Meadows to George Street: Concept Design

Response from Spokes – the Lothian Cycle Campaign, July 2019

This response considers the concept designs and FAQ published at <https://meadowstogeorgestreet.info/>

Detailed route review

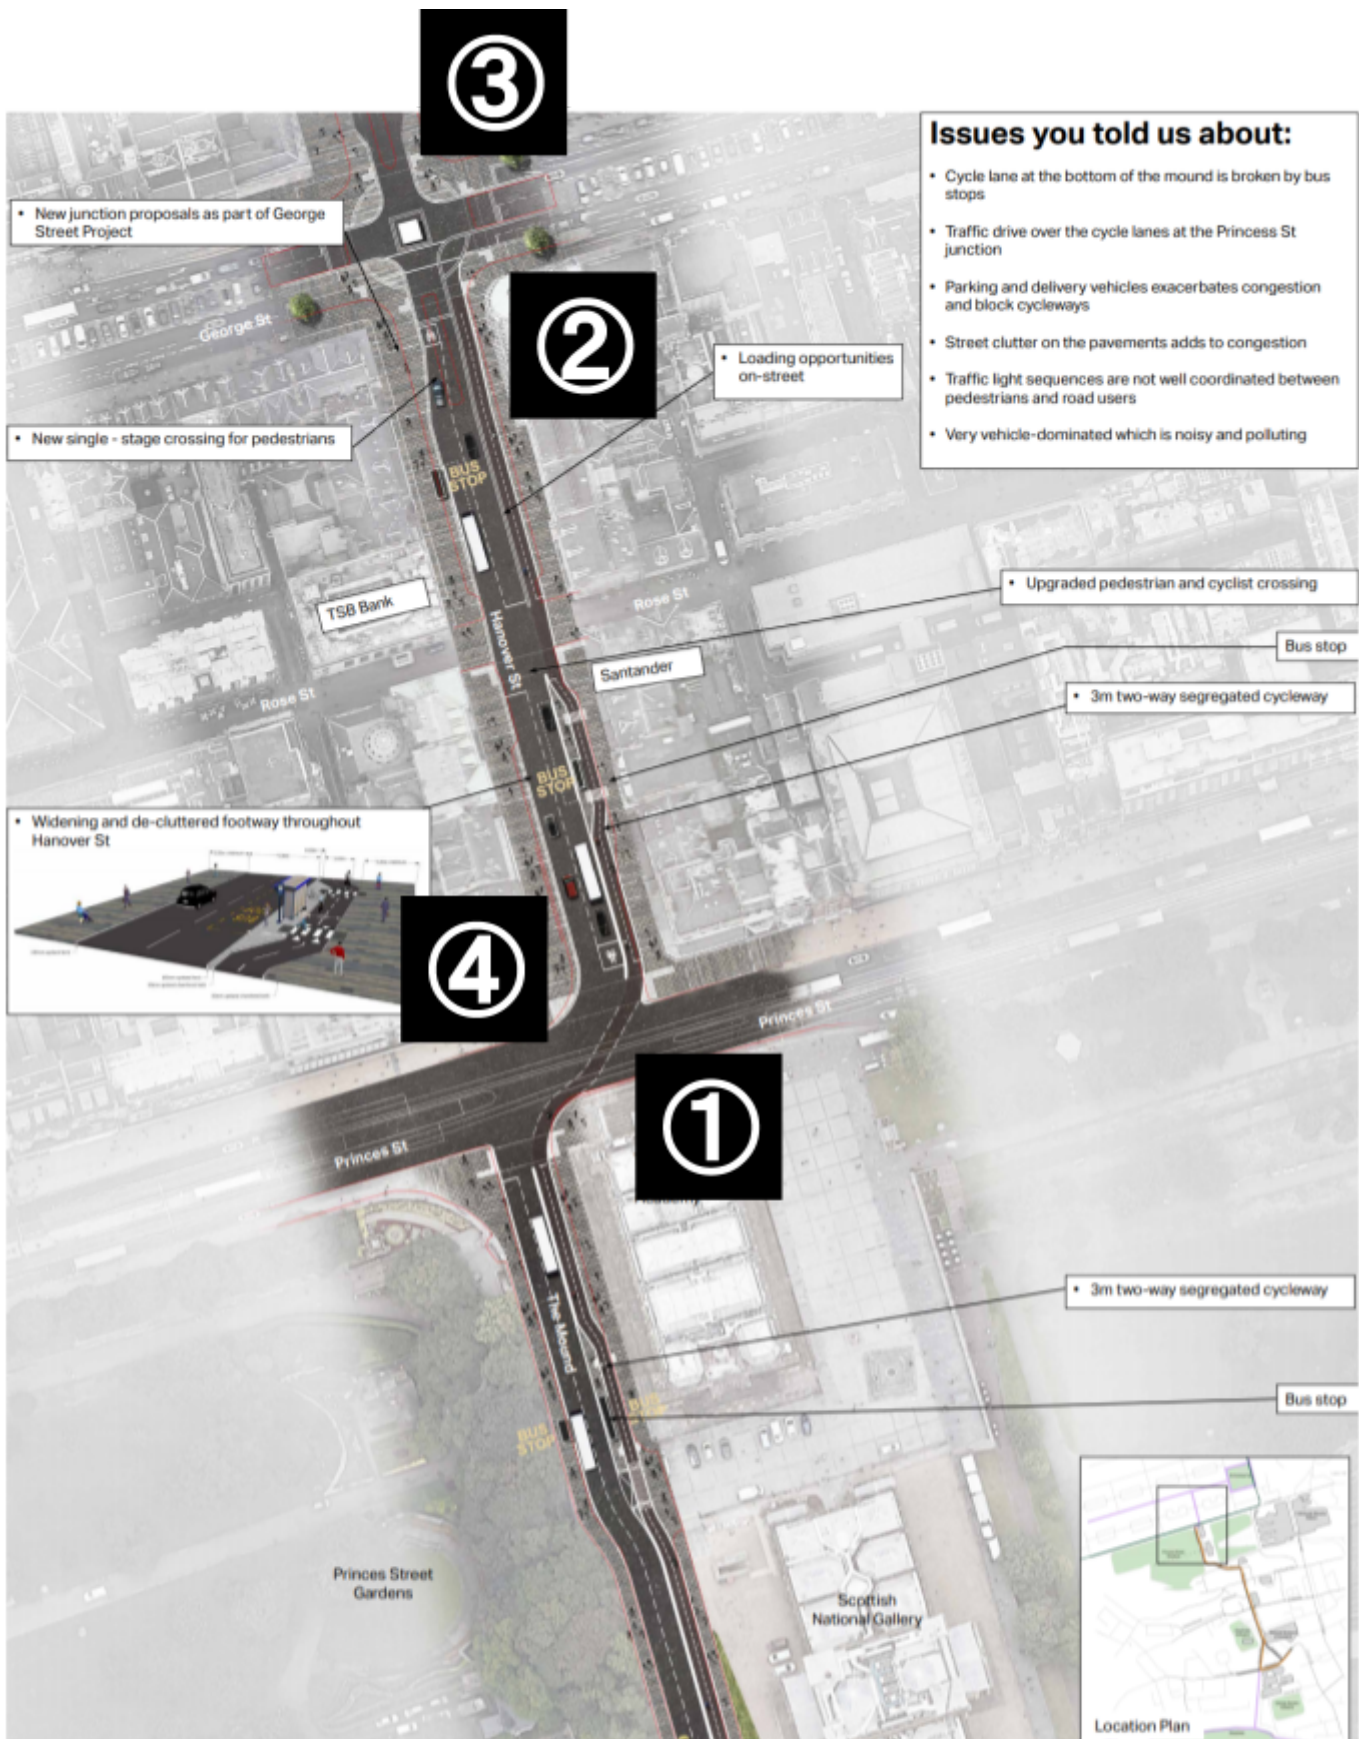
We'd like to thank the project team for providing drawings that combine photo realism with details of markings and surfacing. These are easy-to-understand while still showing details and we hope that future projects will also use this style. We review each drawing over the next few pages.

The Mound and Bank Street

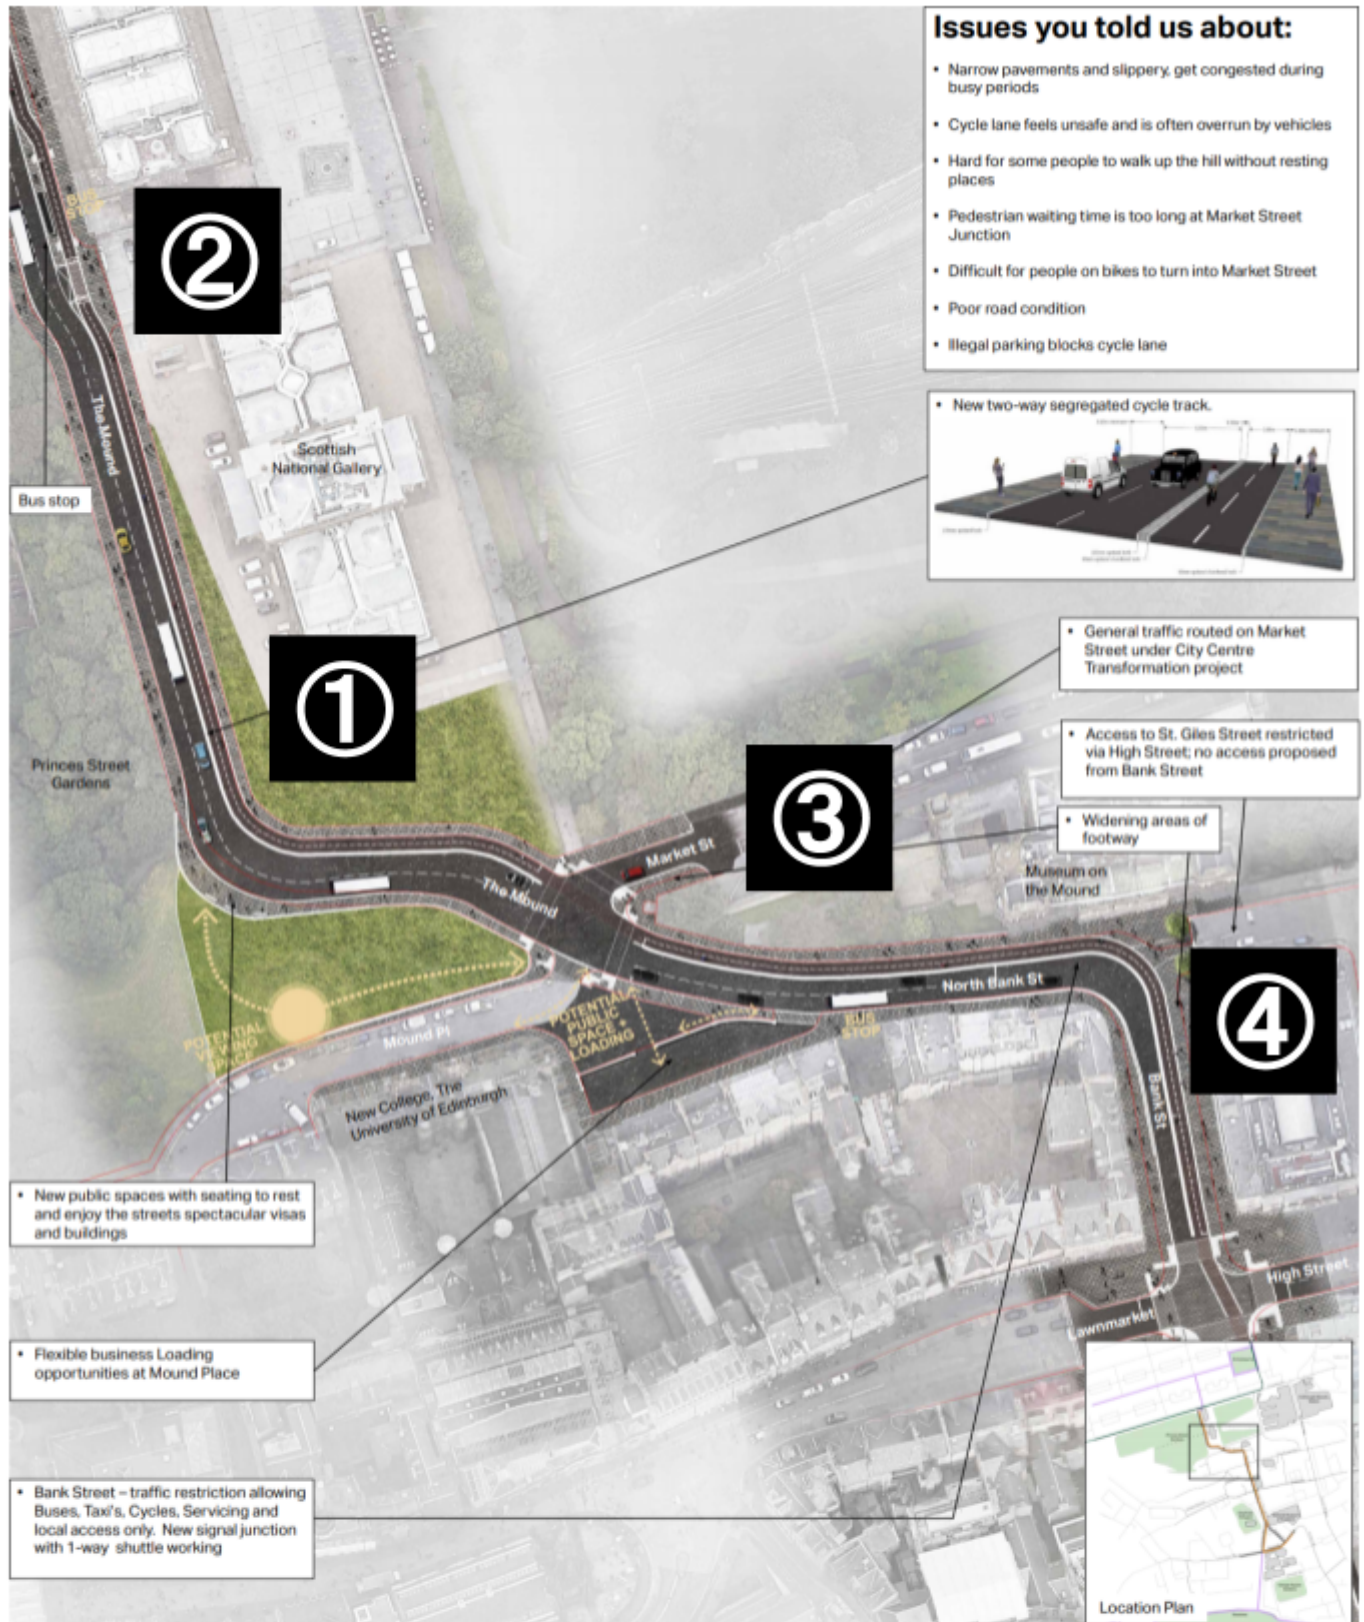
1. **Collision risk on fast corners:** We are concerned about the potential for collisions at the corner on The Mound, and to a lesser extent the corner on Bank Street. At The Mound in particular, the corner is steep, but also wide enough that some downhill cyclists will take it at high speed. There are especially poor sightlines at this corner due to the fence⁶, resulting in a real risk of a downhill cyclist colliding with a slow moving uphill one. Additional cycleway width would help mitigate this, though we recognise that both The Mound and Bank Street corners have width constraints. The only way to make these corners fully safe is to segregate north and southbound cyclists using unidirectional cycleways on this section.

2. **Design of bus stop at the foot of The Mound:** We draw specific attention to this floating bus stop as one where the design will be crucial from a safety perspective. We note that the bus stop is positioned north of the raised table for vehicle access to The Mound Precinct, which should reduce the speed of northbound cyclists coming down The Mound before they reach the bus stop. This same raised table should also have a suitably steep slope on the vehicle approaches to ensure that they give way to cyclists on the cycleway.

3. **Market Street:** The plans omit the cycle lane and ASL at the top of Market Street on approach to its junction with The Mound. It's important that these are retained as there is often queueing traffic on the approach and the cycle lane and ASL enable cyclists to get to a safe position at the front of the queue. Indeed, an early release signal for cyclists would be extremely valuable to provide a head-start on such a steep, uphill start. We also want to know what mitigations will be used to protect cyclists on Market Street from traffic displacement if The Mound is kept open to general traffic.

4. **St Giles Street:** The annotation on the plans says that "no access [is] proposed from Bank Street", while the diagram still shows what looks like a kerb so that vehicles can cross a continuous footway. We hope that no access really does mean no access either from Bank Street or to Bank Street. Allowing access from Bank Street causes a serious risk to cyclists on the cycleway. Allowing access to Bank Street would force the junction to be signalised, and in so doing force cyclists to wait through another junction.
